RAI Volume 3, Chapter 2.2.1.2.1, Sixth Set, Number 4:

Describe how uncertainties in the stress-strain relationships for the Topopah Spring lower lithophysal tuff have been characterized and considered in the UDEC-Voronoi model. Clarify how post-peak strains are represented in the UDEC model for each rock-mass category, such that the effects of brittle deformation have not been underestimated.

Figure 1. Comparison of Stress-Strain Curves Obtained from Tests on 10.5-Inch-Diameter Upper Lithophysal, Saturated Samples with Responses of the Calibrated UDEC Voronoi Block Model

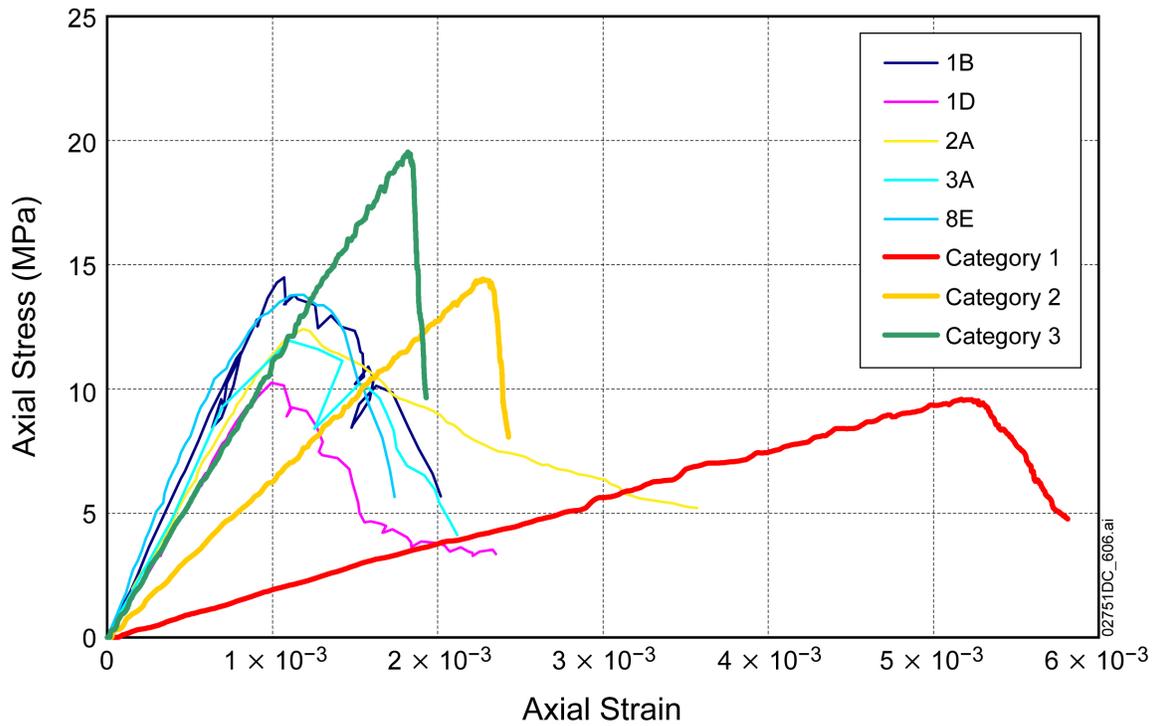
Basis: Although the single comparison between the lithophysal tuff and UDEC calculation for stress-strain characteristics does show a calculated response that is more brittle than exhibited by the laboratory experiment (DOE, 2009, RAI-3), this information does not address the range of characteristics represented by the five lithophysal rock-mass categories used in the UDEC analyses. Additionally, strength characteristics for only six samples from the Topopah Spring lower lithophysal tuff are reported in BSC (2007, Table 6-69). Staff cannot determine if these six samples are appropriately representative of the range of strength characteristics needed to support the UDEC analyses (cf. BSC, 2004, Figure 7-16).

A comparison of the experimental stress-strain curves for all of the saturated 10.5-inch-diameter samples of the upper lithophysal tuff with numerical curves is shown in Figure 1. Note that test data on saturated samples typically had lower strengths than comparable unsaturated samples and the model curves. The saturated samples fell near the lower bound of the strength envelope defining the mechanical property ranges for the five rock mass categories (as shown in SAR Figure 2.3.4-30). Because the UDEC Voronoi data in these plots are for the mean relation between strength and stiffness, the model curves typically show higher strength for the same stiffness. (Development of the relation between strength and stiffness, shown, for example, in Figure E-13, is discussed in BSC 2004, Section E4.1.4.1.) However, comparison of the post-peak softening parts of the stress-strain curves clearly indicates a more brittle model response. That conclusion is more obvious in Figures 2 through 4, in which the curves are roughly divided into ranges of categories and compared with corresponding numerical curves. Brittleness of the UDEC Voronoi block model changes between different categories. As typically observed in rocks, the weaker, less-stiff rocks are more ductile (e.g., Category 1).
